HERITAGE VAUGHAN REPORT

DATE: Wednesday, November 21, 2018 WARD(S): 2

TITLE: NEW CONSTRUCTION – SINGLE DETACHED DWELLING 77 CLARENCE STREET, WOODBRIDGE HERITAGE CONSERVATION DISTRICT

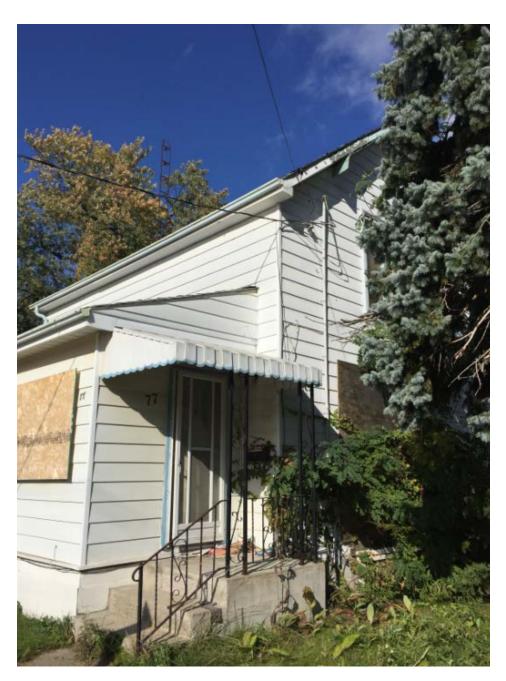
The subject property currently contains a contributing 1925 workman's small cottage (Attachment #3) that is proposed for demolition. The applicant has submitted a Cultural Heritage Impact Assessment ("CHIA") that determined that the building has been altered over time. The front porch was enclosed and amalgamated into the house, new larger windows were installed, and numerous rear additions were added. As an original workman's cottage, it once contributed to the context of the area. The CHIA concluded that the effect of the extensive unsympathetic modifications means that it is no longer representative of the time and style it was built, and therefore no longer fulfills this contributing role in the Woodbridge Heritage Conservation District. The CHIA also concludes that reverting the heavily modified building back to its original form is not feasible since there is not enough of the original building left to restore.

PROPOSED NEW HOUSE VIEW FROM THE CLARENCE STREET

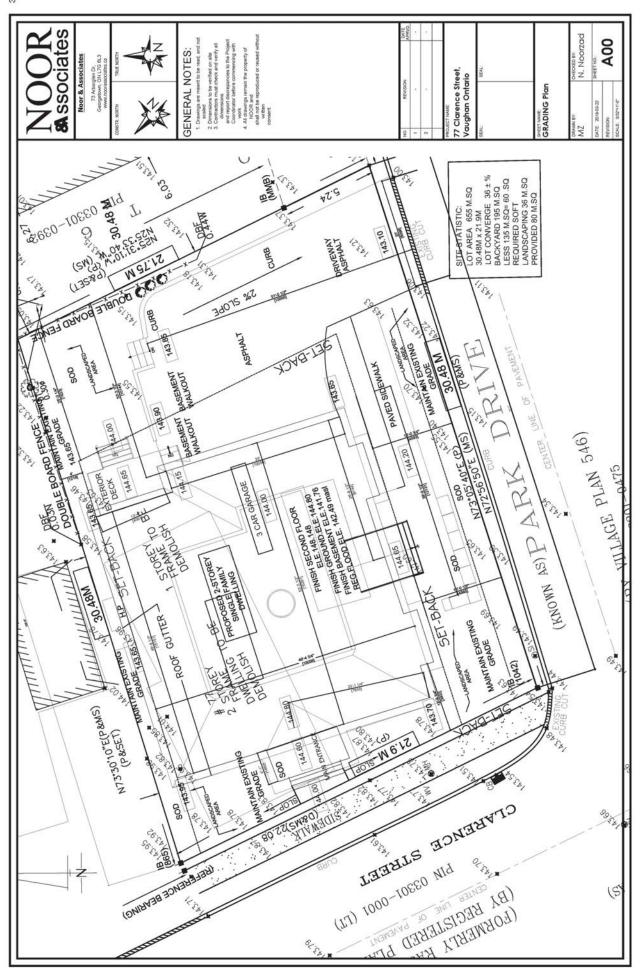
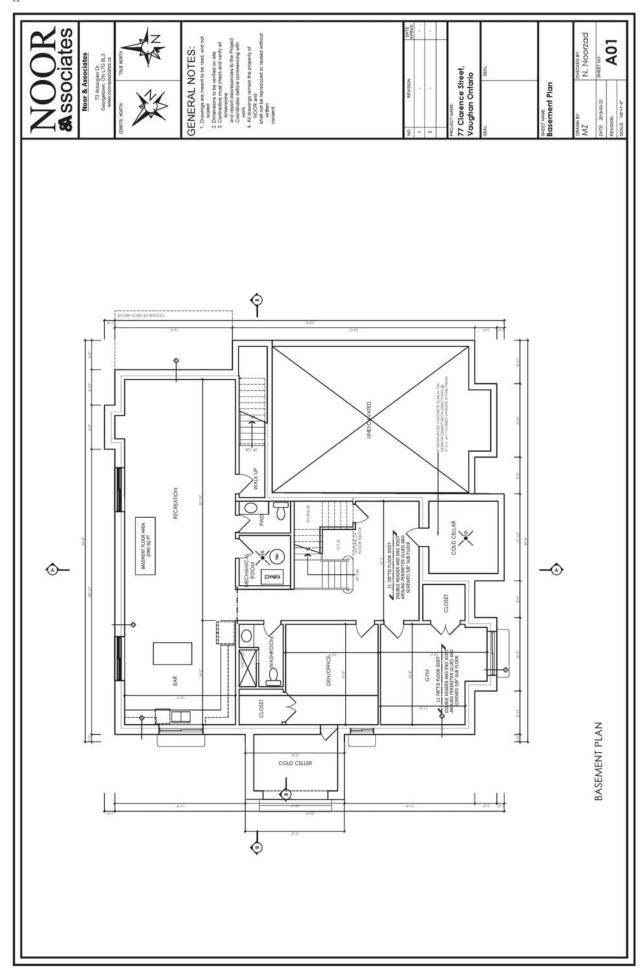
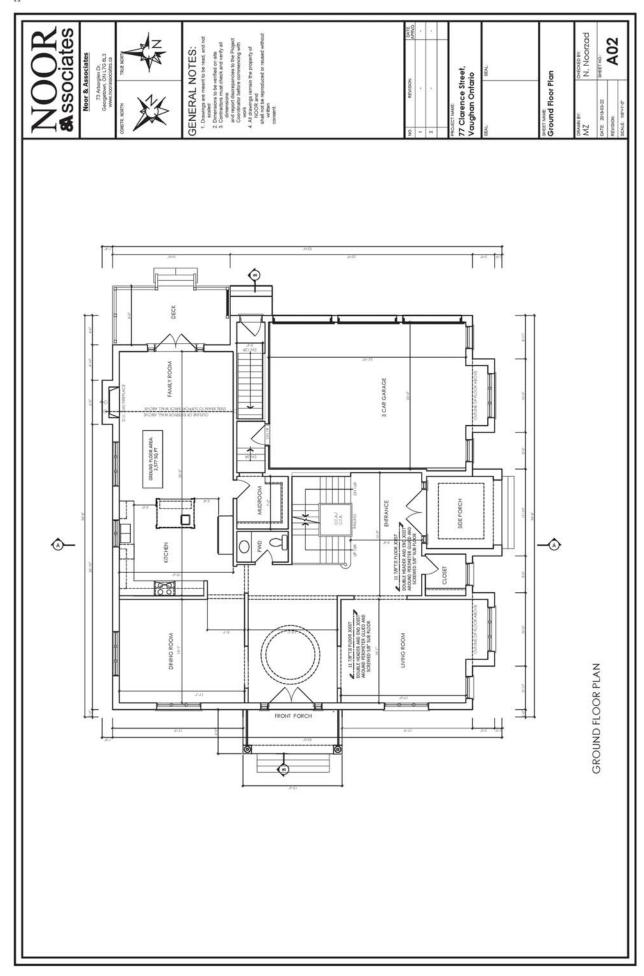
The proposed building height as shown on the submitted elevations (Attachment #4) is 9.15 m from the average finished grade to the top of the flat roof. The proposed building height is under the maximum of 11 m and will be two storeys. This height is supportive of the character of Clarence Street and Park Drive, which contains a range in building heights from 1.5 - 2 storeys. The proposed building height is satisfactory to Cultural Heritage staff. This method of measurement for the building height is consistent with Guideline #3 of Section 6.4.2.1 of the WHCD Plan.

Cultural Heritage staff are satisfied that the proportions of the proposed design fit
within the immediate context of 1.5 - 2 storey dwellings. The massing of the
building is consistent with adjacent dwellings, as depicted in the submitted
streetscape renderings (Attachment #5).

The proposed building is contemporary in style with traditional detailing that references traditional building attributes such as the arched window, window pane configuration and wood paneled doors with sidelights.
